Submission to 100-day Review of Brisbane 2032 Olympic and Paralympic Games Infrastructure and Planning

The Games Independent Infrastructure and Coordination Authority

The risk of groundwater-dependent Koala Habitat Loss caused by construction of an Olympic 2032 Whitewater Course on the Birkdale Community Precinct

Figure 1: East-west koala movement across the site is blocked by about 4/5 of the path presently available

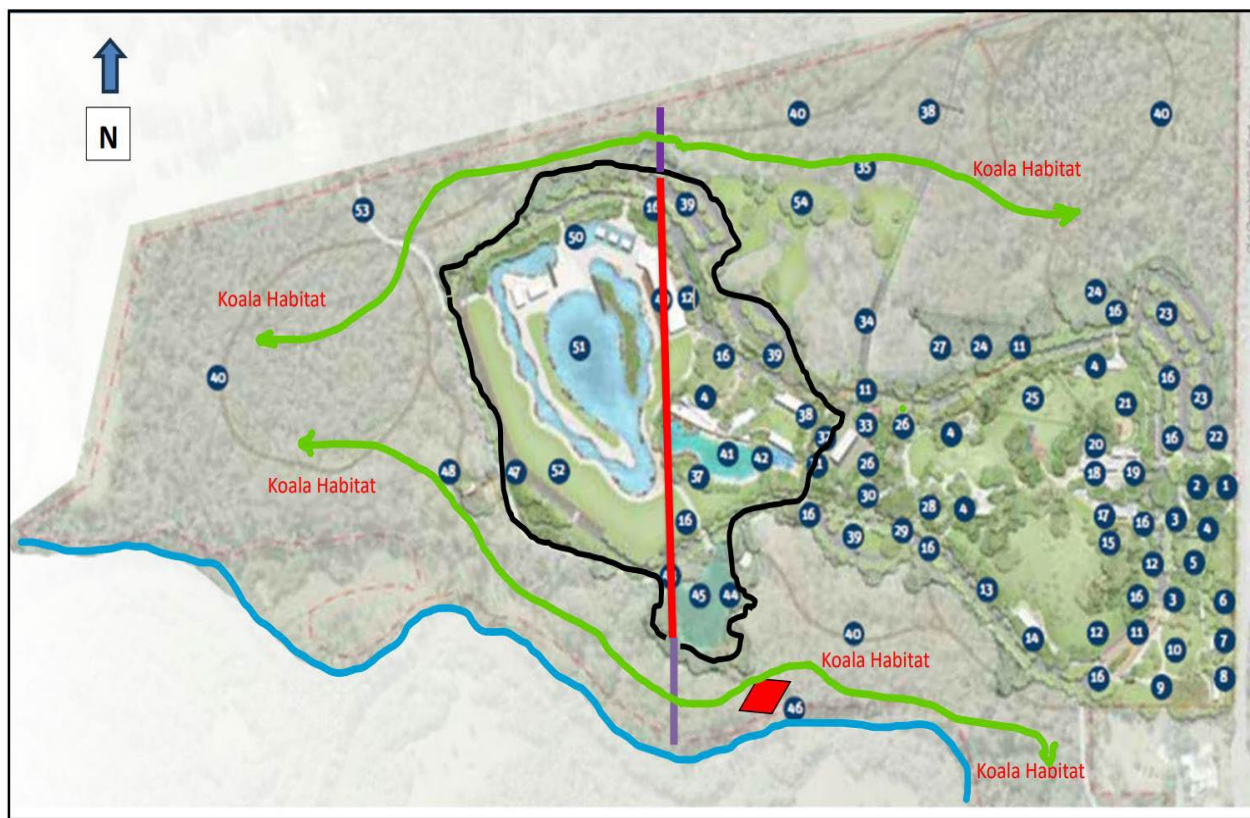
An early draft of the Conservation Agreement between Redland City Council and the Commonwealth Government (2019) mentioned in a report¹ available on the RCC website, emphasised the importance of allowing fauna movement across the site. The Birkdale Community Precinct Master Plan shows fauna movement will be blocked by the Whitewater Centre and proposed lagoon. Figure 1 shows almost four fifths of east-west fauna movement will be blocked by the Whitewater Centre and the lagoon. (Base map is from the Redland City Council’s Master Plan for the Birkdale Precinct with our additions showing koala movement.) Koalas in the Redlands are in such a tenuous position that any changes in their usage of the habitat can have profound effects on the remaining koala population.

Presently available corridor: purple + red + purple lines = 560 metres. After construction: only purple line in south = 65 metres (further blocked by pinch point at canoe launch shown by red diamond); and purple line in north = 50 metres. NB Measurements approximate – property lines as shown on Master Plan (RCC website). Outline of koala impervious WWC (fences, wet areas etc.) ——— Koala east-west movement across site – after WWC →
 Tingalpa Creek ———

Figure 3 Jacobs Preliminary Civil Drawings of 19 April 2023

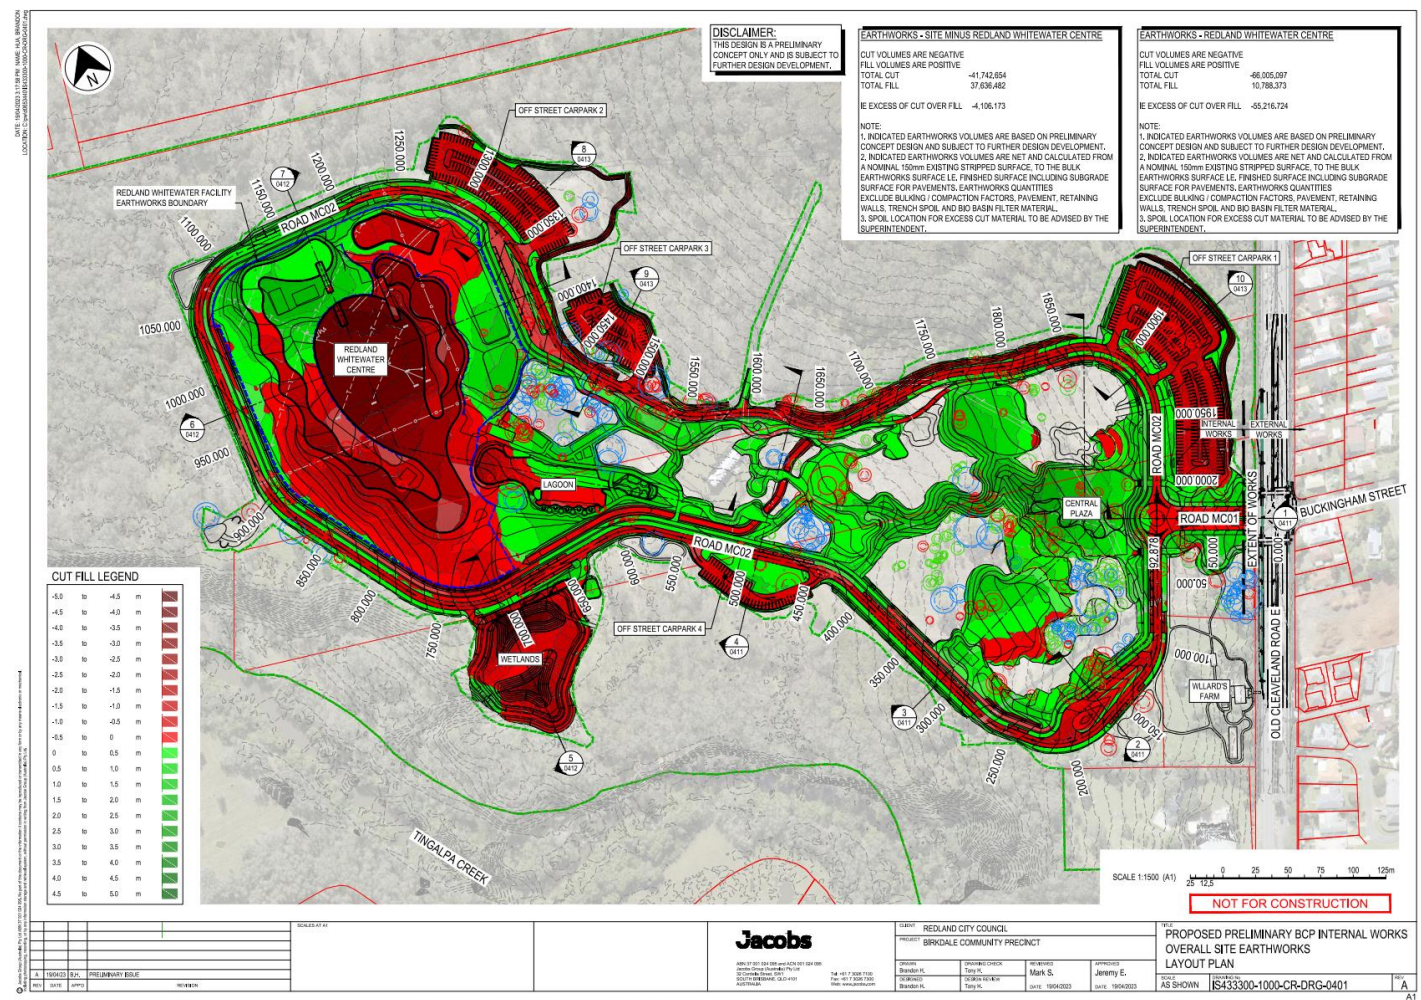
In particular, the drawing in **Figure 3** below shows **excavation depths for Whitewater channels and basin**.

Figure 3 shows the **Plan View** of the proposed site earthworks and end-state modified site topology (green = raised, red = excavated). It provides the **scale and context** to assess potential impacts on the site's hydrogeologic attributes such as surface/ subsurface flow redirection, groundwater infiltration and aquifer recharge.

Also, in comparing this Figure 4 Core Koala Habitat mapping overlay to **Figure 3**, it appears that significant Core Koala Habitat **will be lost** to areas identified for the Redland Whitewater Centre and for general Birkdale Community Precinct public car parking.

*Figure 4 Forested Core Koala Habitat surrounding Birkdale Community Precinct
(Source: Core Koala Habitat Areas – Qld Globe qldglobe.information.qld.gov.au - with our overlay)*

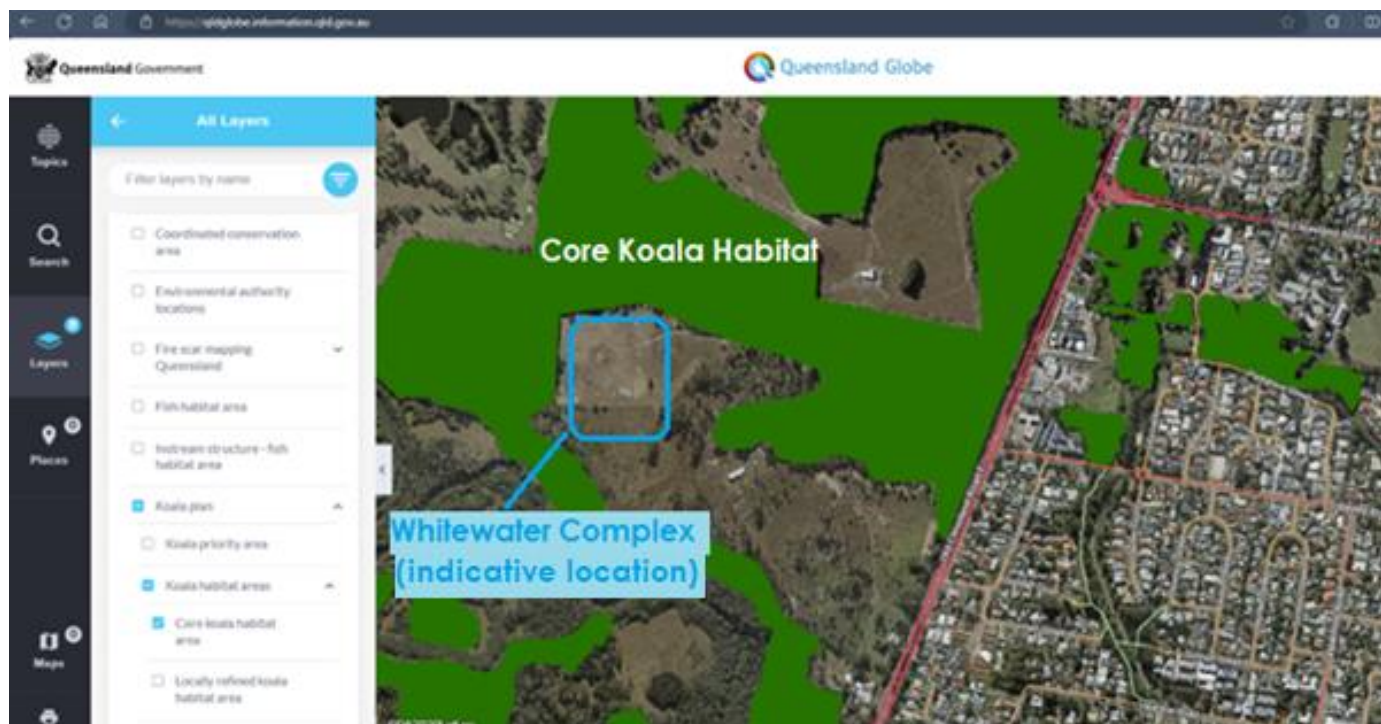
Figure 4 below describes the zoning overlay of Protected Core Koala Habitat, classified as **Matters of State Environmental Significance (MSES)**, located substantially within the BCP and bordering to the north and west of the proposed Whitewater complex.

In terms of likely **negative impacts on the resident koala population**, the Figure 4 map shows:

- the close ground-level proximity of major Whitewater earthworks and –
- the potential for resultant noise, dust and other destructive impacts of its construction in such close proximity to impact protected Core Koala Habitat.

Figure 8 BCP underlying aquifer structure

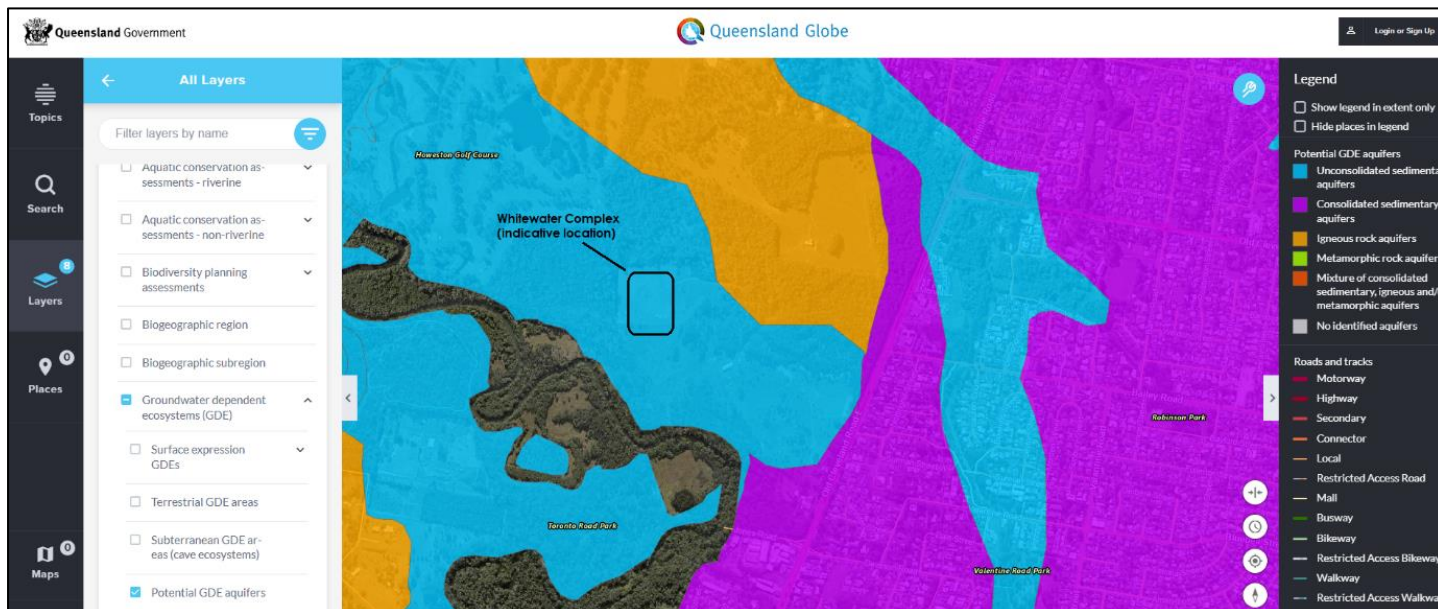
The aquifer structure **overlaying the Whitewater site** and BCP is classed as an **‘unconsolidated sedimentary aquifer.’**

The unconsolidated aquifer underlying the BCP site is **considered fundamental to establishing the Core Koala Habitat/ GDE relationship**, as tree root systems permeating this layer derive moisture from groundwater inflows or rising water table dynamics independent of any rainfall.

Figure 10 Geotechnical Bore map (apparent errors highlighted in yellow)

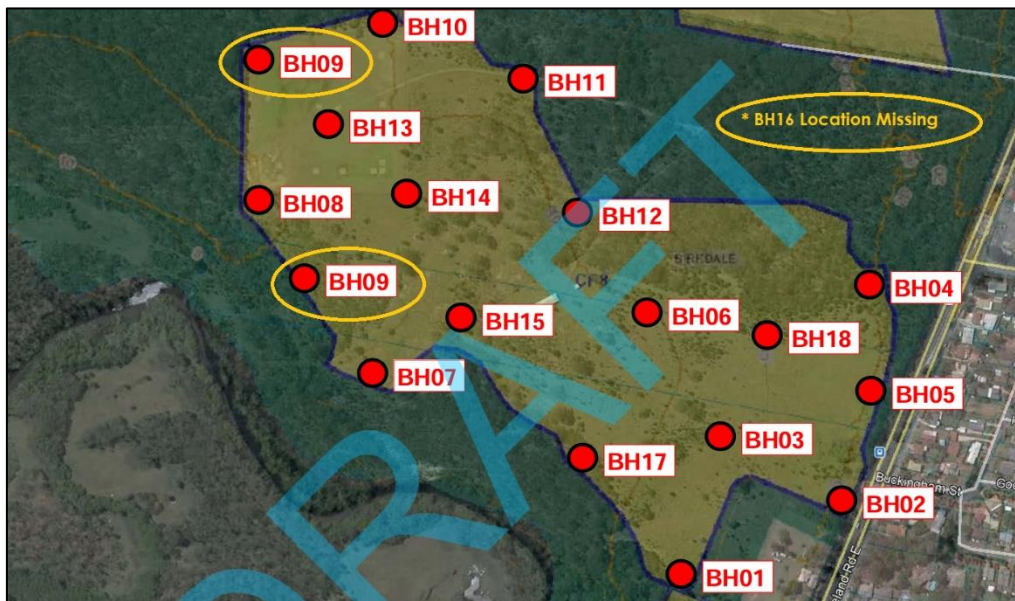
On reviewing the drilling configuration (as per Bore Hole sitings published in Document 3, labelling errors (duplicates) were detected, triggering further inspection. See **Figure 10** below.

Figure 11 Corrected GPS bore coordinate mapping

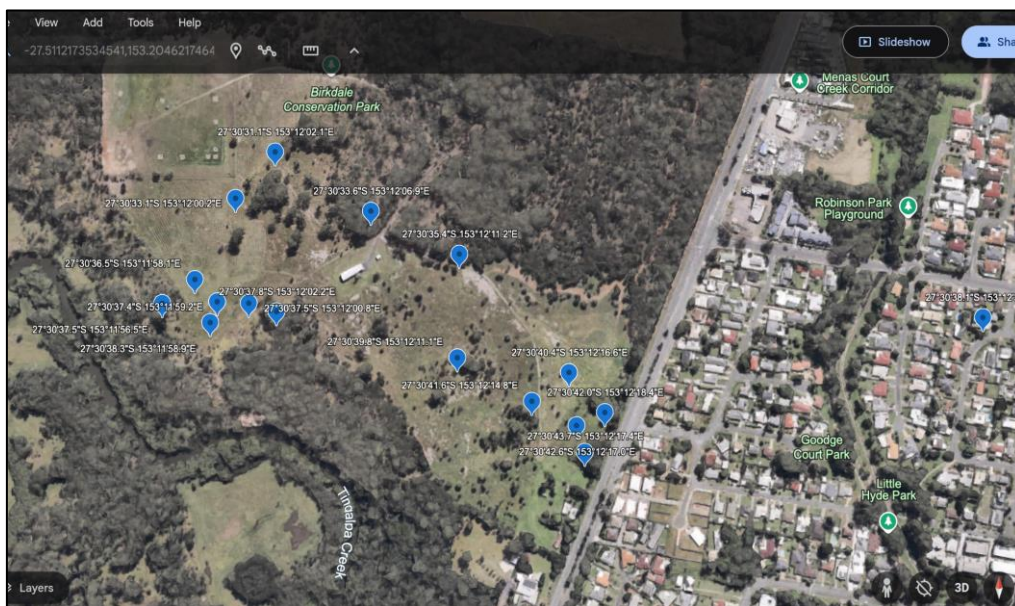
The corrected mapping in **Figure 11** shows **bores more clustered** than indicated in Document 3, and an **absence of drilling within or near** the anticipated **footprint** of the Whitewater Basin and Channel excavation.
